# MC34709, Silicon Errata (N88D)

This errata document applies to the MC34709 data sheet.

**Figure 1. RTC Workaround Application Circuit**

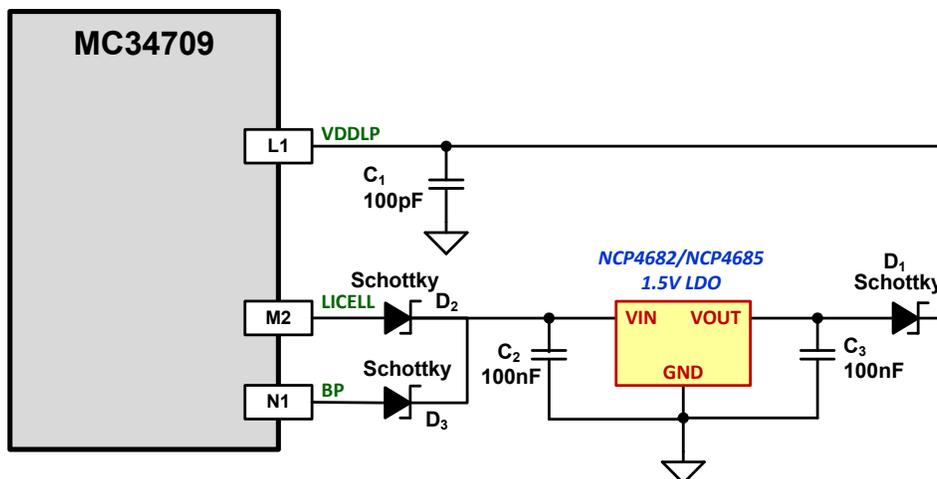
Errata Number	Erratum	System Impact	Description
<b>High Severity Level</b>			
4	<b>Buck Regulator:</b> Regulator output undershoot in APS mode.	Undershoot may cause processor to shutdown.	<p>In APS mode the regulator output may undershoot for approximately 10 <math>\mu</math>s under transient loads of 1/2 of max rated current. Output voltage may drop as much as 160mV.</p> <p><b>Workaround:</b> SW1-5 must be operated in PFM mode for loads lower than 100 mA and in PWM mode for loads greater than 100mA in order to meet the transient load response specification.</p> <p><b>Fix Plan/Status:</b> No fix scheduled.</p>
5	<b>RTC:</b> VSRTC drops out with slowly decaying battery and a valid coin cell.	<p>In applications with a Li-Ion battery, the RTC can be lost when the battery voltage drops to <math>\sim</math>2.2 V.</p> <p>In applications where VBATT is driven by an external source, the RTC can be lost as the voltage transitions below the 2.2 V range during power down.</p>	<p>There is an issue with the 'Best of Supply' switch, which powers VDDL P. During the change over from the primary power source to the coin cell, the VDDL P can dip to a voltage below the minimum voltage required to power the RTC.</p> <ul style="list-style-type: none"> <li>The VSRTC supply is derived from VDDL P, and therefore affects the RTC of the application processor, as well as the on-board RTC</li> <li>The 32 kHz clock to the processor's SRTC also drops out.</li> </ul> <p><b>Workaround:</b> Figure 1 is the application circuit recommended for all applications where the RTC is used with a back-up coin cell attached to the MC34709. The LDO output is set to 1.5 V with a Schottky diode in series which keeps the voltage supplied to VDDL P below the VCOREDIG (1.5 V).</p> <ul style="list-style-type: none"> <li>Add a low quiescent current 1.5 V LDO, supplied by the coin cell (LICELL pin). Recommended LDO: NCP4682/4685<sup>(1)</sup> or equivalent with a 1<math>\mu</math>A typical IQ.</li> <li>Add a low voltage Schottky diode (D1) to block the output capacitance (C3) of LDO.</li> <li>Add a low voltage/low leakage Schottky diode (D2) from LICELL to VIN of the LDO.</li> <li>Add a low voltage/low leakage Schottky diode (D3) from BP to VIN of the LDO.</li> </ul> <p><b>Fix Plan/Status:</b> No fix scheduled</p>
